Include product

tWF-PD4R3, tWF-PD4SR2A, tWF-PD4SR2D, tWF-PD8, tWF-R6, tWF-DA1PD2R1
ALM-06-WF

Description of changes

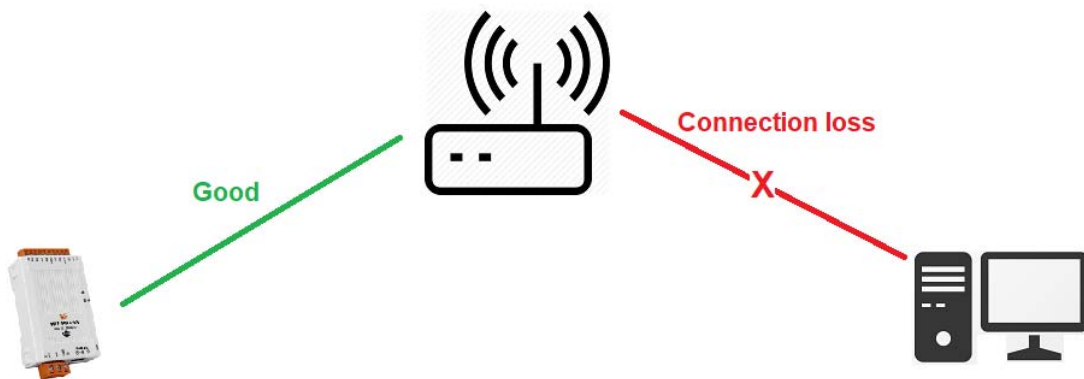
Add timeout for Modbus TCP, connection idle in STA(Station) mode. When both device & Host/Controller connected to an AP(Access Point) in STA mode, if Host/Controller break & loss the connection with AP, it will cause the device hang in a dead connection(device still good with AP, even Host/Controller get back with new connection, but it's not the same socket number as the original). To prevent it happen, set a timeout for device to restart the connection and wait for next connect.

The Idle Timeout for Modbus TCP connection (default is **120 Sec**), user can change it from PC utility, Android APP, HTML or Modbus TCP Command.
